# DESIGN ALERT

## DESIGN ALERT INDEX - CURRENT

Design Alert Number	Issue Date	Subject	Verify or Modify Date
003C2B-DA-149	10-01-2018	Patient Privacy and Women Veterans' Health, Design for	
003C2B-DA-148	06-01-2017	VA Standards Application and User Design Input Requirements	
003C2B-DA-147	09-01-2016	VA Project Design Principles – Foundation of Design	
003C2B-DA-144	06-01-2015	Revisions to Telecommunications Systems Uninterruptable Power Supply Requirements	
003C2B-DA-142	06-01-2014	For Immediate Application on All Current Projects Patient Safety in VHA Bathrooms	11-01-2014
003C2B-DA-138	04-19-2012	Indoor Water Features, Decorative Fountains Recommend Non-Use	
003C2B-DA-132	05-01-2008	Pharmacy Design Guidance, Update on Compliance with USP 797 "Pharmaceutical Compounding – Sterile Preparations"	
003C2B-DA-121	09-15-2004	Mycobacterial Laboratories – BSL3 Labs Architectural and Engineering Controls Update

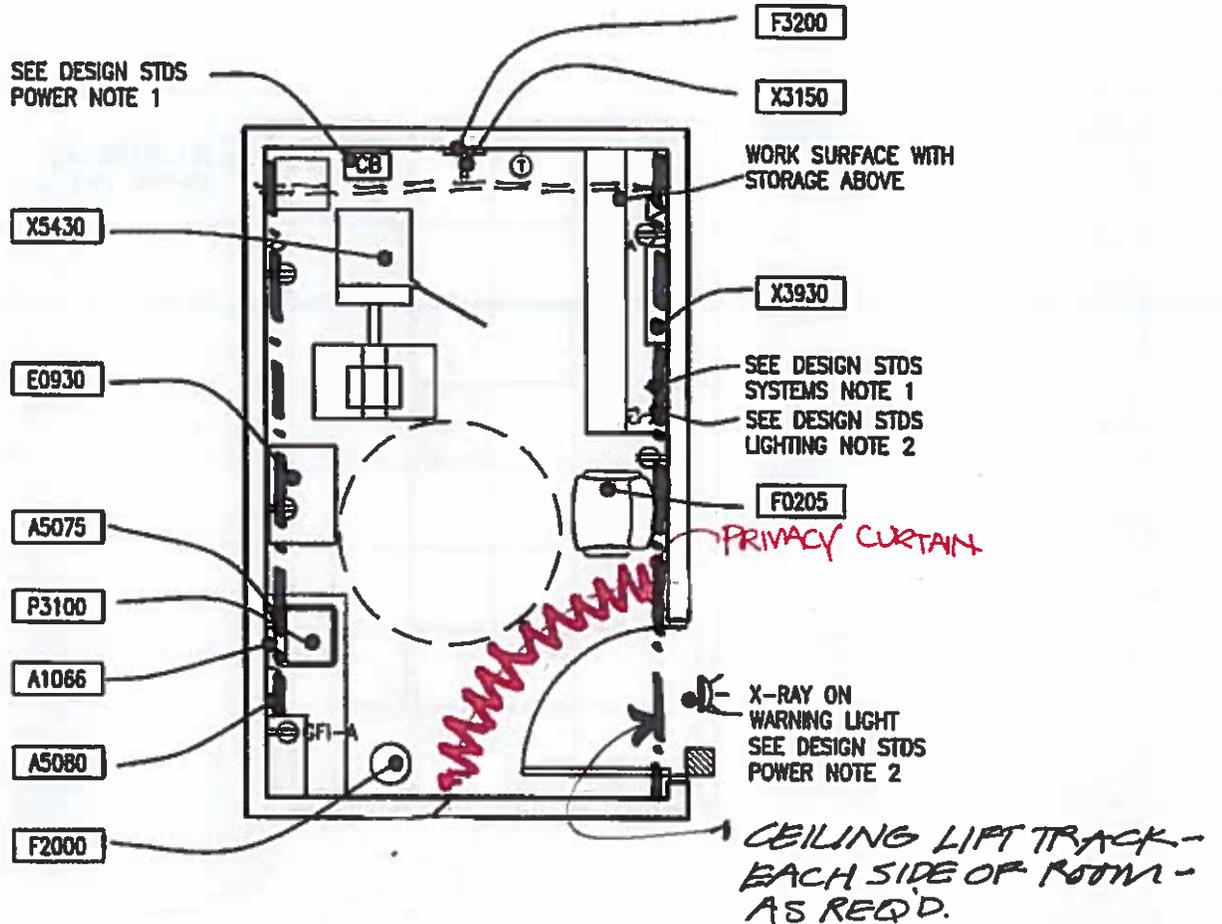
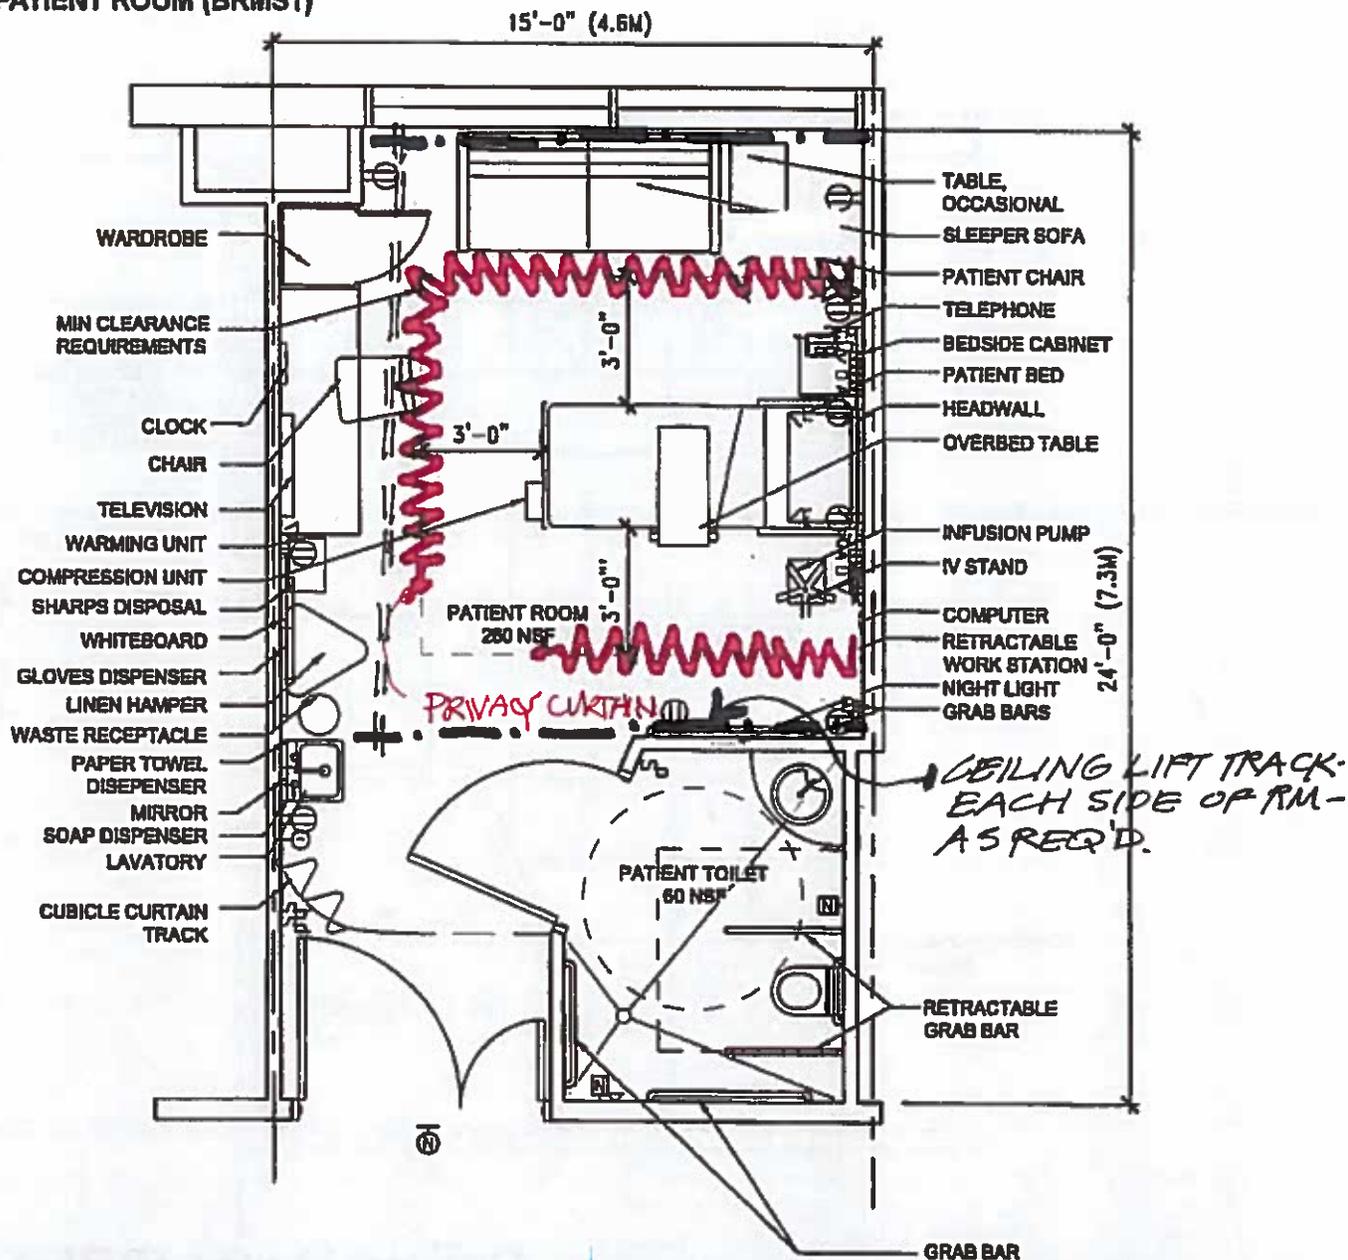
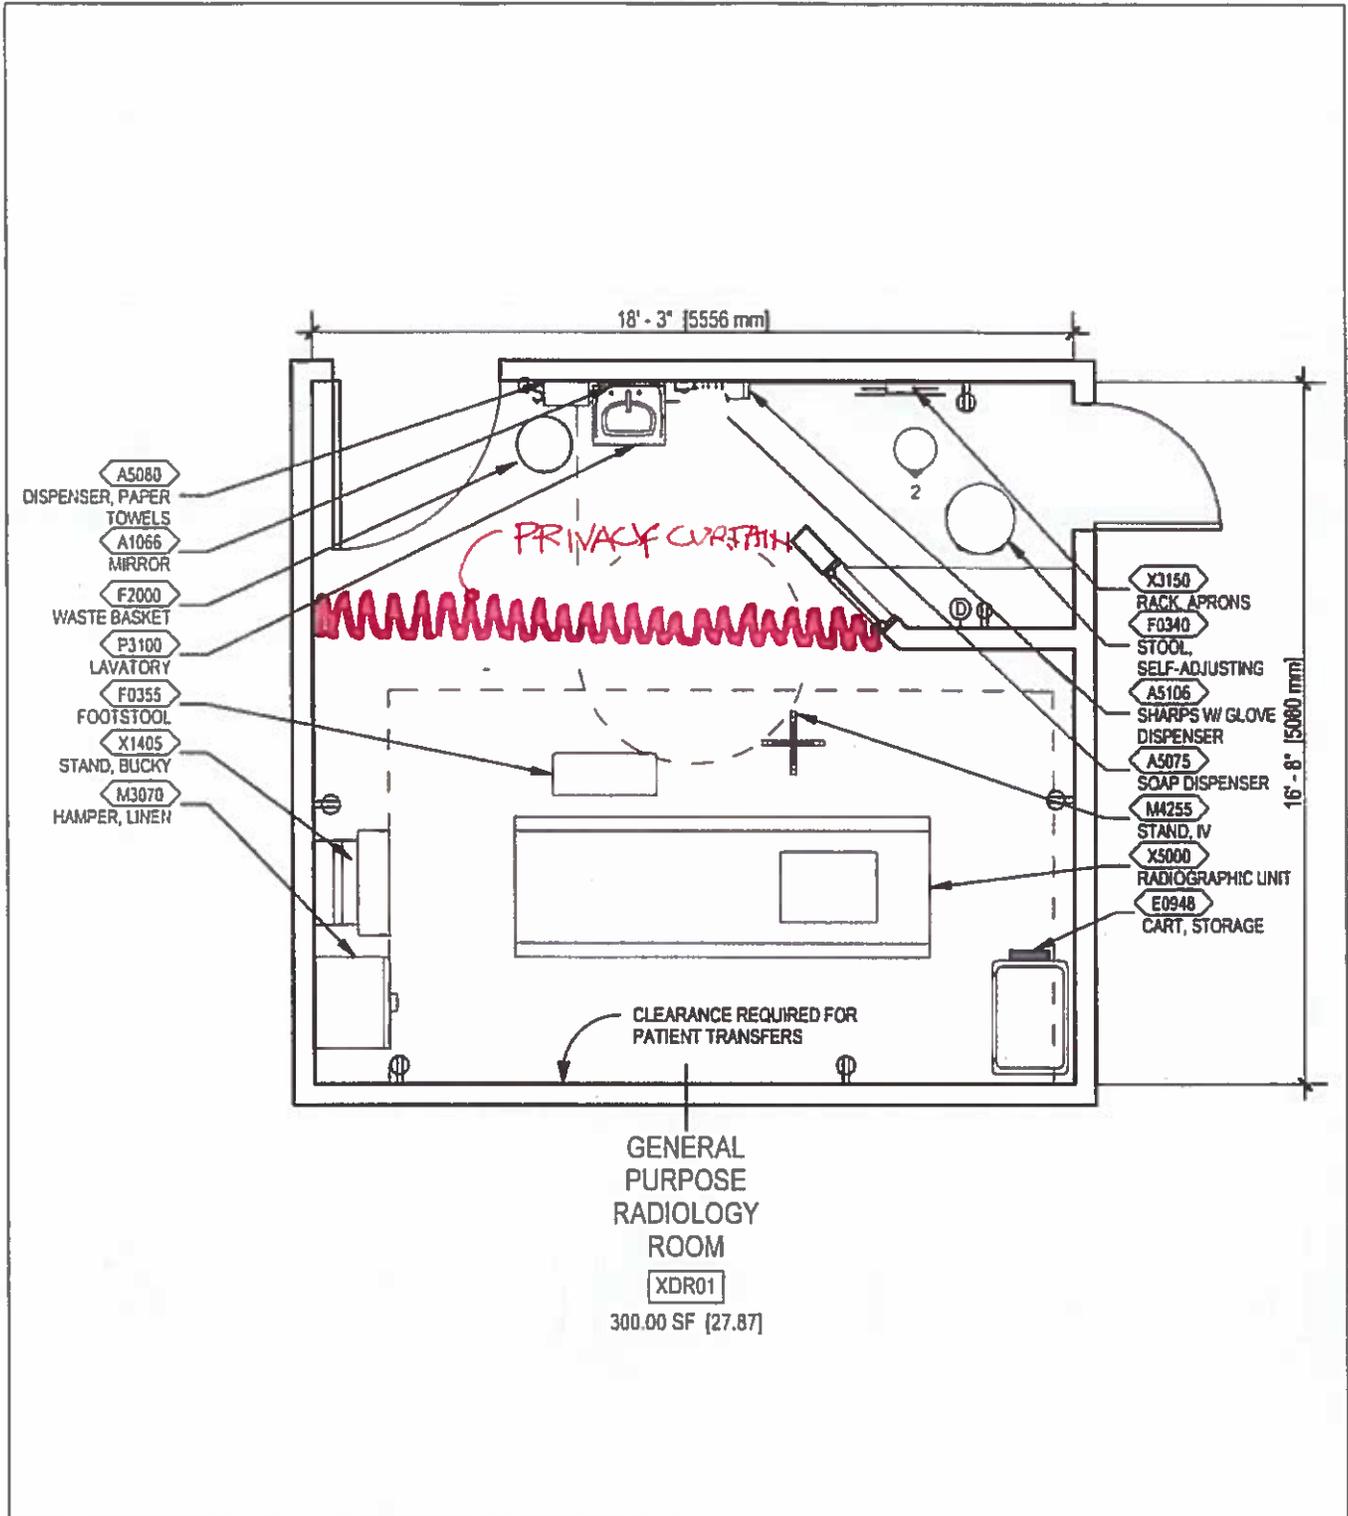
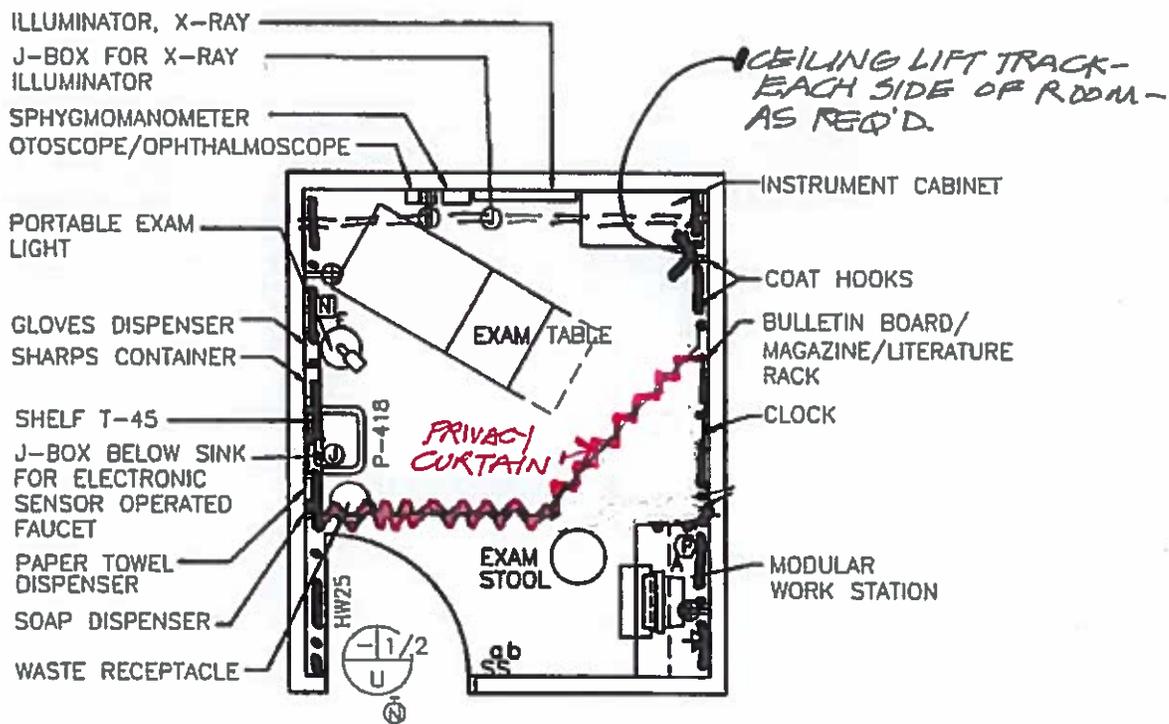
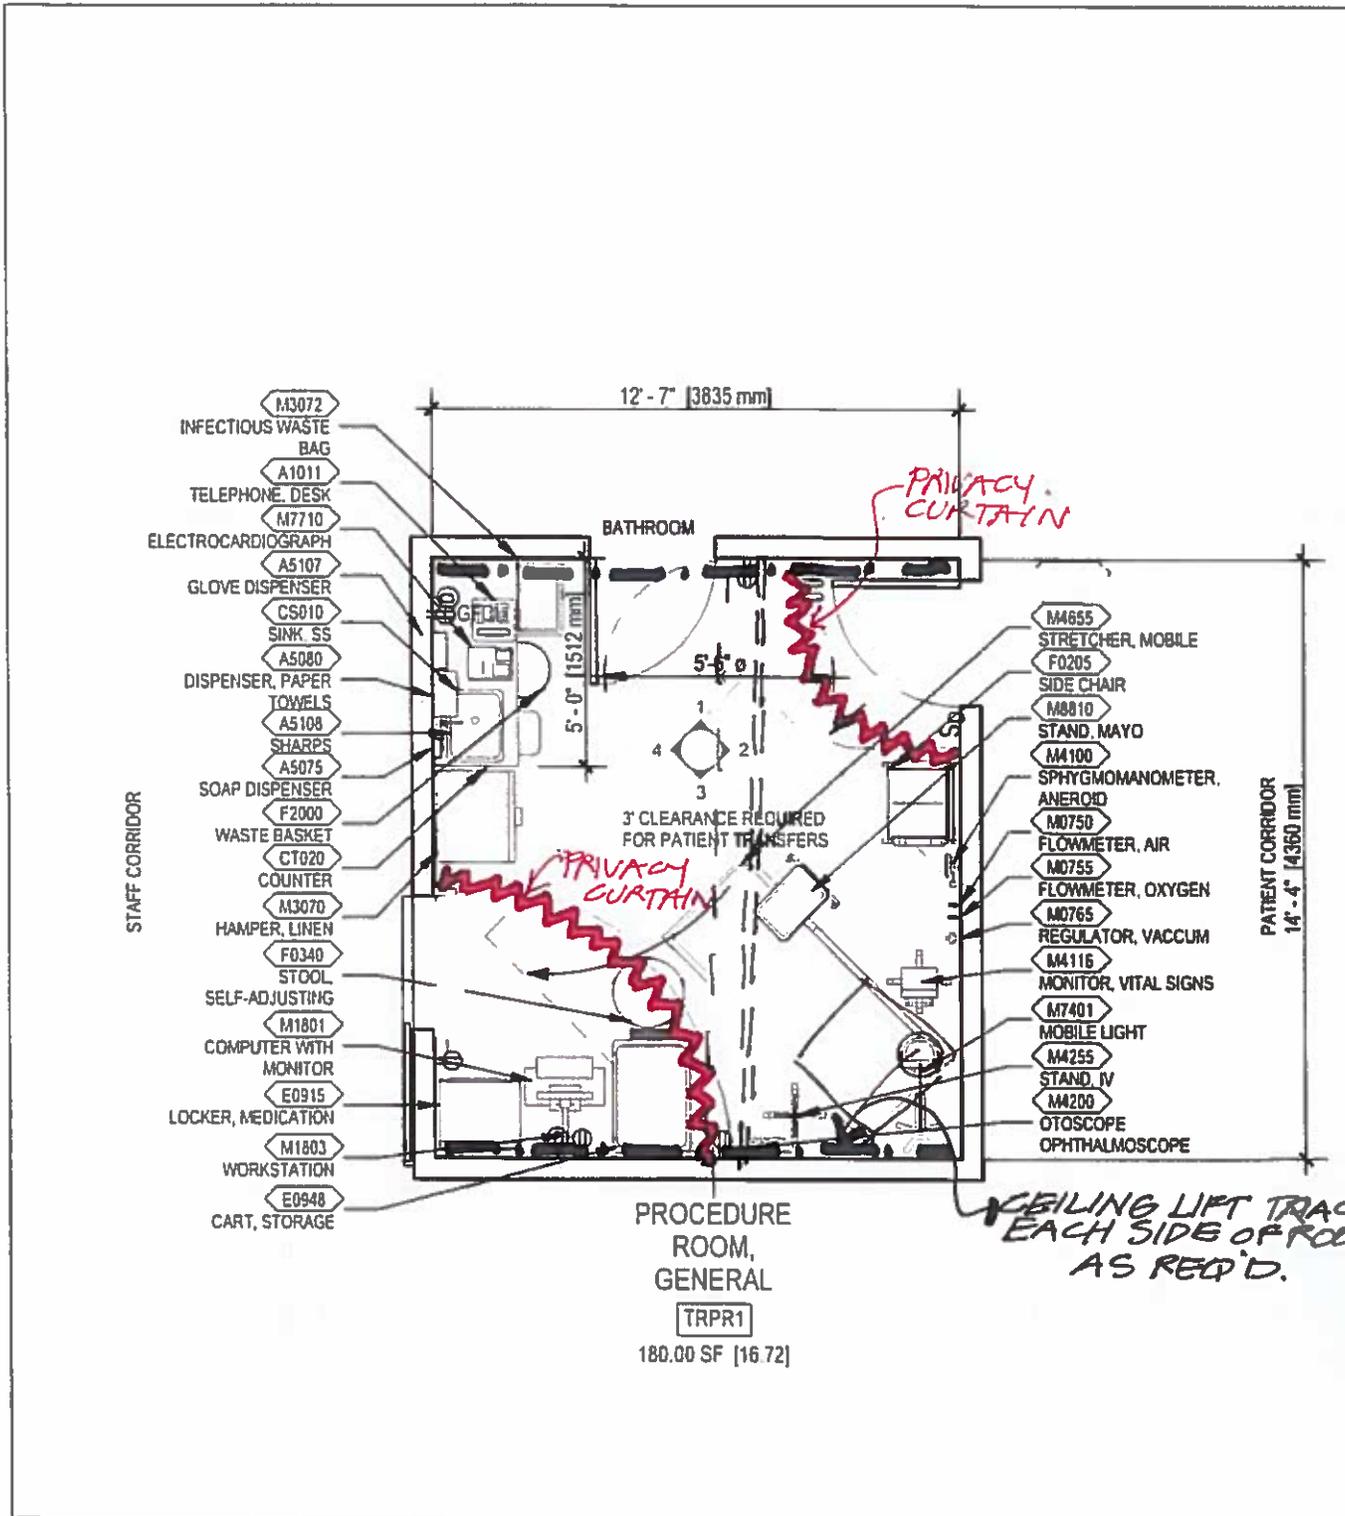
- b) Privacy Curtains / Screens – See attached Room Illustrations. In extenuating conditions, disposable privacy curtains, portable screens, integrated blinds in glass, or other similar systems must be considered. If, due to specific existing conditions or operational requirements, it is not possible to provide a visually private patient changing area, the facility must establish a policy to ensure patient privacy while changing.

- (1) Examination, procedure, and treatment rooms- provide privacy curtains/screens to encompass adequate space for the healthcare provider to perform examination unencumbered by the curtain, and provide a visually private patient changing area that allows the provider to remain in the room.  
Exception: Patient care rooms where a patient does not have potential for exposure of breast or genital areas.

- (2) In-patient rooms (private / semi-private / multi-patient) - Provide privacy curtains to encompass adequate space for healthcare provider to perform bed-side examination unencumbered by the curtain. In these rooms the primary purpose of the bedside curtain is to provide the patient visual privacy from the room entry door during an examination or treatment and secondarily a visually private patient changing area where the provider, or other healthcare staff, can remain in the room.  
Exception: Patient rooms in: Mental Health in-patient units, Intensive Care Units, Recovery, Emergency Departments, dedicated airborne infection isolation rooms, and other rooms with infection control concerns. In these rooms, provide disposable privacy curtains, portable screens, integrated blinds in glass, or other similar systems.
